SUBJECT: COBRA 139XLR MODIFICATIONS

PROBLEM A. TR-36/R153 Crystal drift due to overheating.

PROBLEM B. PCB cracking or breaking due to rough handling.

FIGURE 1

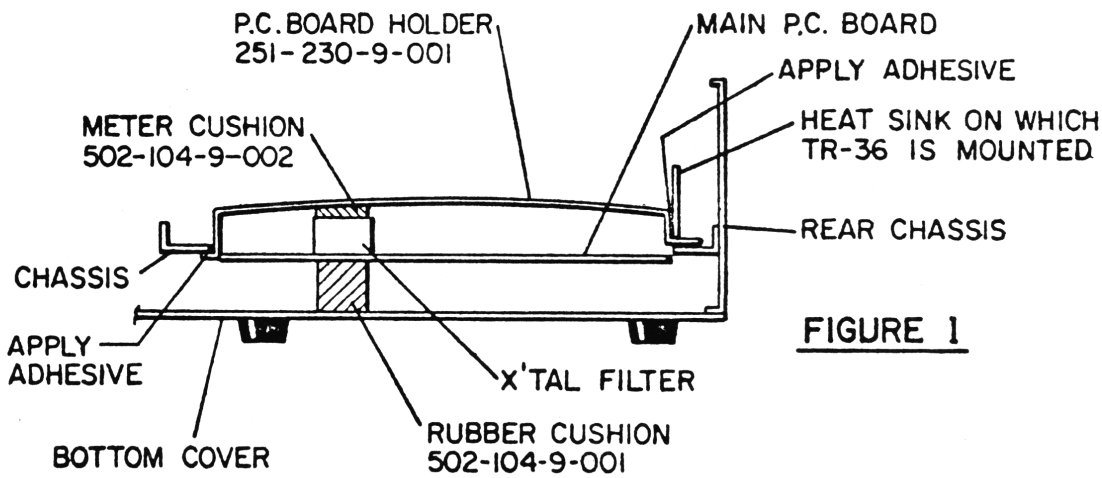
15. Reinstall bottom cover, and turn radio over to upright or normal position.
16. Paste two meter cushions (520-104-9-001) on top of Xtal filter (Fig.1).
17. Install a piece of masking tape on underside of PC board holder (251-230-9-001) so as to sheathe burrs and sharp edges.
18. Install PC board holder (Longer flange under auxiliary heat sink, shorter flange under chassis) Fig.I

FIGURE 2

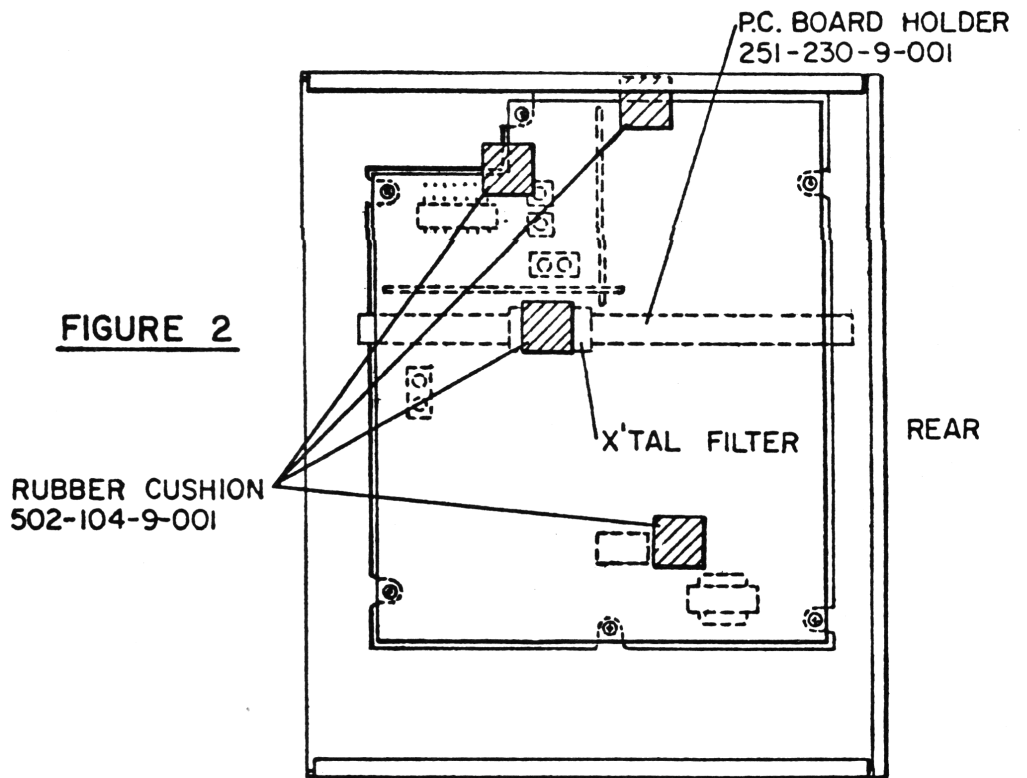
14. Remove backing paper from four rubber cushions (502-104-9-001) and paste cushions on solder side of PC board (Fig 2).

To avoid damaging lead wires or components, locate rubber cushions in areas of board that are clear of lead wires and components.

FIGURE 3

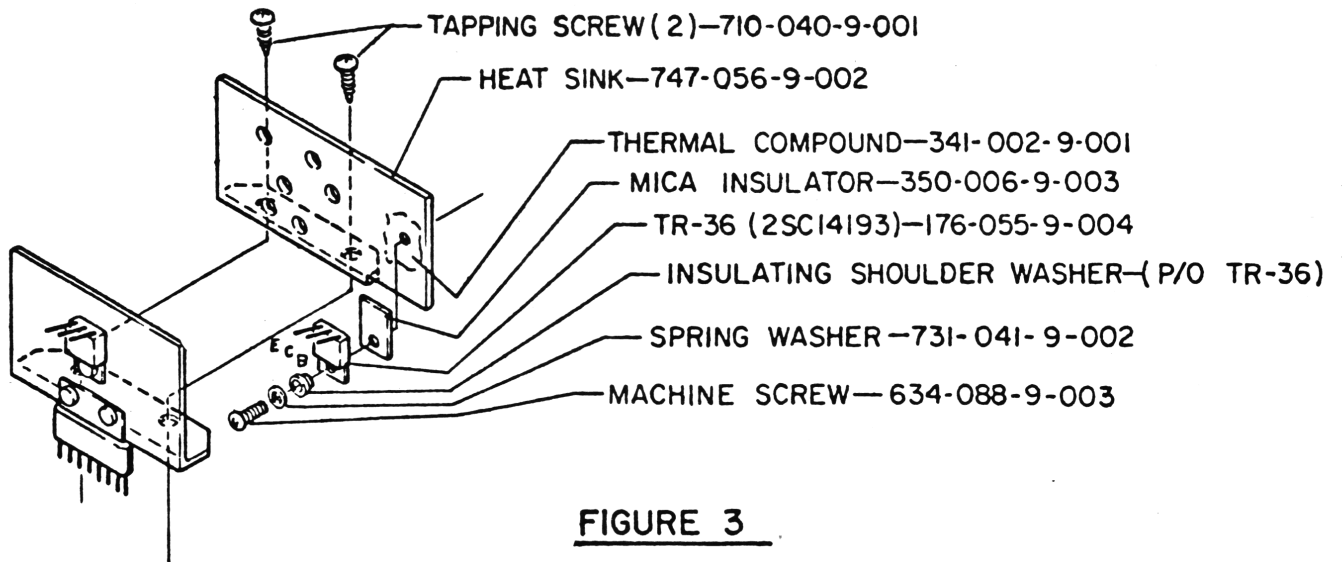
7. Unsolder and remove TR-36 from present location.
8. Mount TR-36 on auxiliary heat sink (747-056-9-002 supplied with this mod. kit) using the existing hardware and insulators (Fit.3). Apply thermal compound (341-002-9-001) on both sides of mica insulator before installation. When installing insulated shoulder washer, make sure that the smaller end seats in transistor hole. When tightening transistor mounting screw be careful not to damage insulated shoulder washer.
